## VENDOR SERVICE PUBLICATION

SUBJECT: Bendix Service Bulletin No. 629

Inspection and replacement of certain Bendix Aircraft Magneto Brown Distributor Blocks as used on turbocharged six (6) cylinder engines.

Figure 1  
D-2000/D-3000 Series  
Batch Codes 0000 through 8552

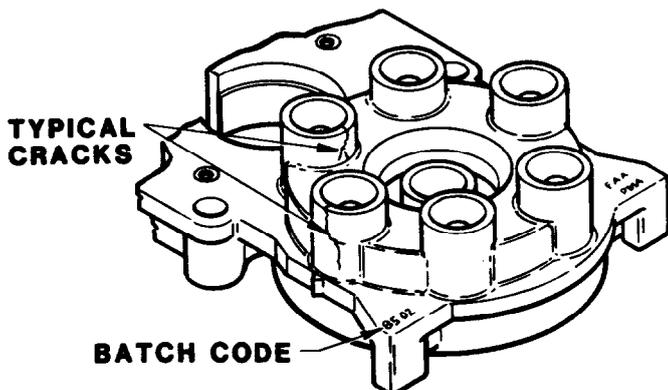
To remove from service distributor blocks that may contain outlet tower cracks. See Figures 1 through 3.

Note A: All blocks are identified with a code. The codes are molded into the outer periphery of the block and only blocks with listed codes are affected. See Figures 1 through 3.

Field reports indicate some brown distributor block towers may crack (ref. Figures 1 through 3). Should the tower or towers crack the indications could be loss of ignition to the associated spark plug(s) or possible misfiring and/or cross firing of the engine.

1. Following published procedures, remove the harness cover or adapter plate from the Magneto. Using a high intensity light, inspect each distributor block tower for open cracks as shown in Figures 1 through 3.

CAUTION: BEFORE FURTHER FLIGHT, BLOCKS FOUND WITH CRACKS MUST BE REPLACED BY BLOCKS WITH BATCH CODES NOT LISTED AS AFFECTED UNDER THE "EQUIPMENT AFFECTED" SECTION OF THIS BULLETIN. FOLLOW PUBLISHED PROCEDURES.
